Access Compliance Report

Public Rights-of-Way

(Curb Ramps)

Intersection ID: 48867	Main Street: ERWIN_RD	Cross Street: LION_CUB_LN	Location: SW
ADA ID: 04F8FBE67BE3	Ramp Type: PerpDiag	Initial Pass/Fail: Fail	Overall Compliance: No
Severity Score: 37.5			
Codes/Mitigation Info/Possible Solution		Field Measurements/Component Compliance

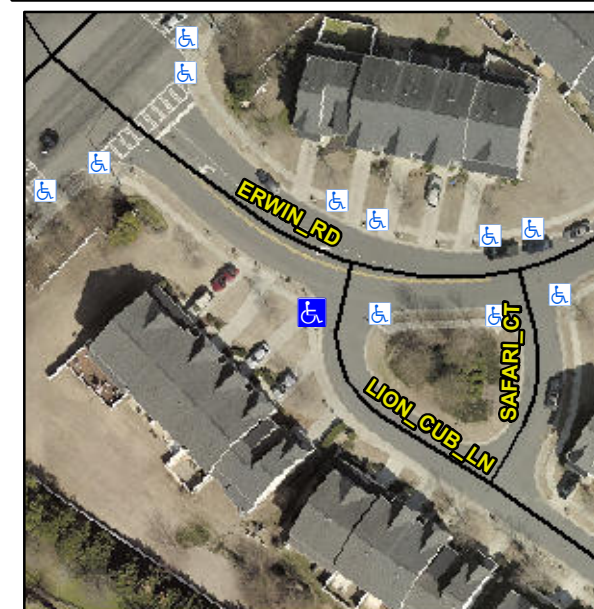
R304.2.2, R304.5.3

Compliance	Description	Data	Compliance	Description	Data
N/A	Ramp Length (in)	28.0	No	Ramp Slope (%)	14.5
Yes	Ramp Width (in)	48.0	No	Ramp XSlope (%)	5.3
N/A	Flare Type LT	N/A	N/A	Flare Type RT	N/A
N/A	Flare Slope LT (%)	N/A	N/A	Flare Slope RT (%)	N/A
N/A	Flare Traversable LT?	N/A	N/A	Flare Traversable RT?	N/A
N/A	Landing Length (in)	N/A	N/A	DWS Provided?	N/A
N/A	Landing Width (in)	N/A	N/A	DWS Contrast?	N/A
N/A	Landing Slope (%)	N/A	N/A	DWS Length (in)	N/A
N/A	Landing X Slope (%)	N/A	N/A	DWS Full Width?	N/A
N/A	Landing Curb? (Y/N)	N/A	N/A	DWS Offset (in)	N/A
N/A	Shared Landing?	N/A			
N/A	Gutter Ponding?	N/A	N/A	Gutter Slope (%)	N/A
N/A	Gutter Lip Ht (in)	N/A	N/A	Gutter X Slope (%)	N/A
N/A	Painted X Walk1?	No	N/A	Painted X Walk2?	No
	X Walk 1 Direction	To E		X Walk 2 Direction	To N
N/A	X Walk 1 Width (in)	N/A	N/A	X Walk 2 Width (in)	N/A
	X Walk 1 Slope (%)	0.4		X Walk 2 Slope (%)	2.3
	X Walk 1 X Slope (%)	3.8		X Walk 2 X Slope (%)	3.4

Remove & Replace Curb Ramp With Two New Directional Ramps or Equivalent.
